TITLE: Eastridge Residential Development ZONE ATLAS/DRNG. FILE #: J-22/D49

DESCRIPTION: Tract A, Block 12-A Panorama Heights

GRADING & DRAINAGE PLAN EASTRIDGE RESIDENTIAL DEVELOPMENT

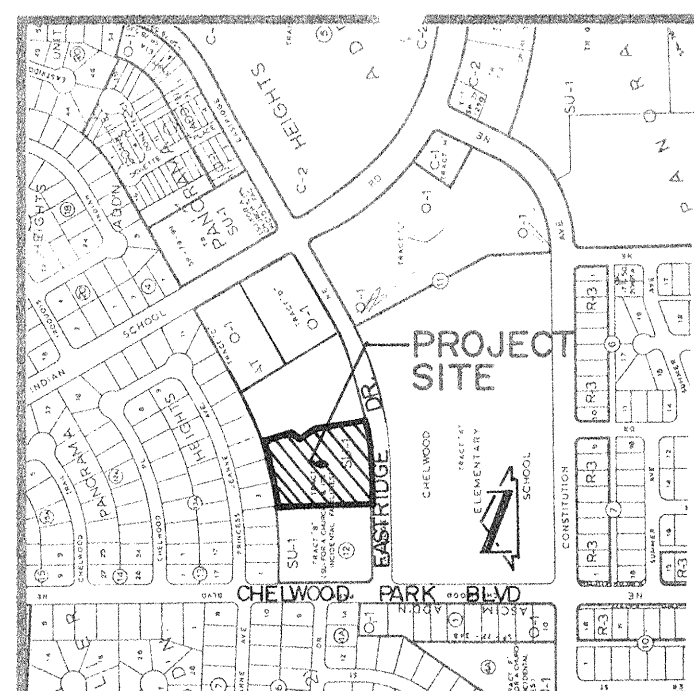
A field inspection has revealed that a raised landscape area along the north property line has been graded to drain through a turned block between the recently constructed retaining wall and the existing garden wall. This condition could result in seepage of Eastridge runoff through the garden wall into private property. Please be advised that this situation is inconsistent with the approved grading and drainage plan submitted to the Hydrology Office. Additionally, there were some concerns about the pad elevations but a survey has verified that the pad elevations are at or below the designed elevation.

Also, there were some questions concerning height requirements and setback requirements which have been referred to Zoning for investigation.

To avoid any damage to adjacent properties, please look into this matter at your earliest convenience. If you have any questions or comments, please feel free to call me at 764-1699.
